LAST ISSUE OF ANALOG DIALOGUE Vol. 7 (1973), No. 1

If you missed the last issue, you were also a bit fortunate to have missed one of our more-devastating errors: the power-supply connections of the AGC circuit (page 13) were reversed. The correct circuit is shown below. If you have that issue, please scrawl the following changes on the figure now:

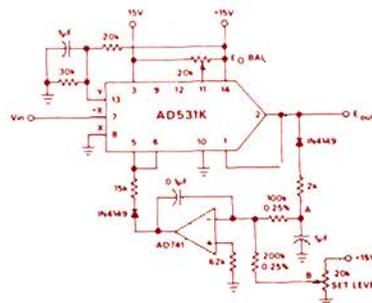
1. Exchange the polarities of +15V and -15V to pins 14 and 3
2. Reconnect the fixed 20k resistor to +15V
